REPLACEMENT SYSTEM VARIANCE REQUEST

SUBSURFACE WASTEWATER DISPOSAL SYSTEM APPLICATION

Re: Septic System
Togus, ME

Enclosed are three copies of a revised page 3 drawing of your septic system.

SUBSURFACE WASTEWATER DISPOSAL PLAN

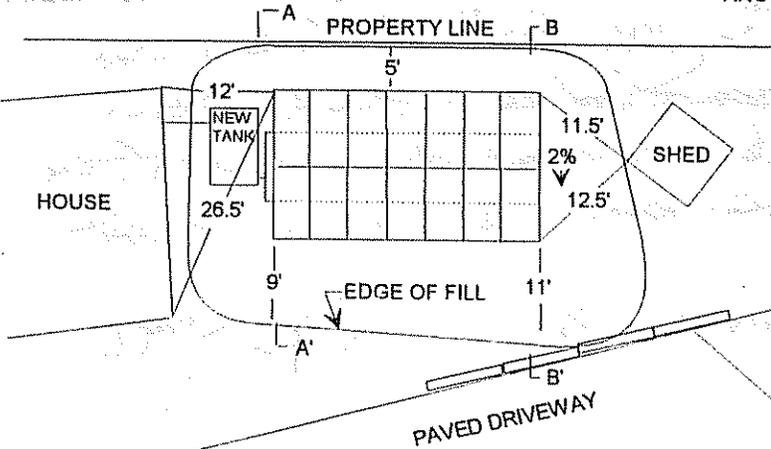
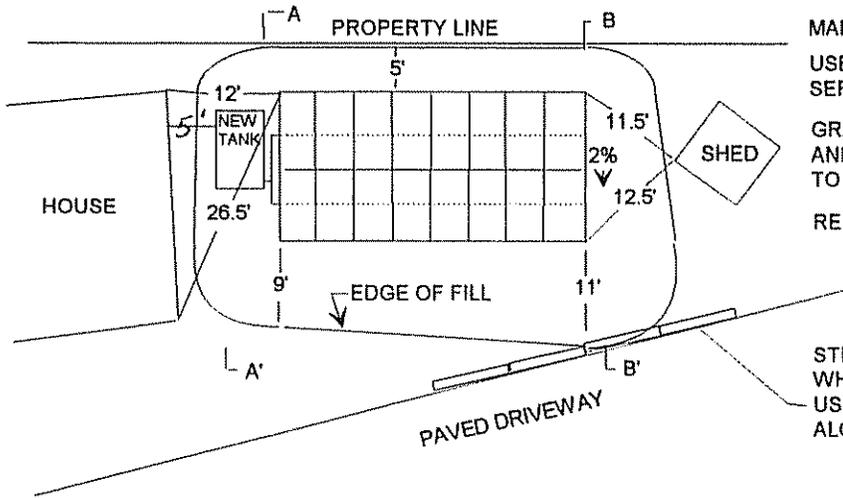
The original drawing showed 16 concrete chambers on the plan. The correct number should have been 14. These are the 4 ft by 8 ft chambers.

REMOVE EXISTING CONCRETE SEPTIC TANK THAT IS IN THE AREA OF THE PROPOSED SYSTEM
BACKFILL TO GRADE WITH COARSE GRAVELLY SAND
USE 14- 4' X 8' CONCRETE CHAMBERS WITH SIDE ENTRY DISTRIBUTION
OVER EXCAVATE AREA OF PROPOSED SYSTEM 6 INCHES BELOW ELEVATION OF THE CHAMBERS. REPLACE WITH VERY COARSE GRAVEL
EXTEND A ONE-FOOT WIDE PERIMETER OF COARSE GRAVEL AROUND THE CHAMBERS
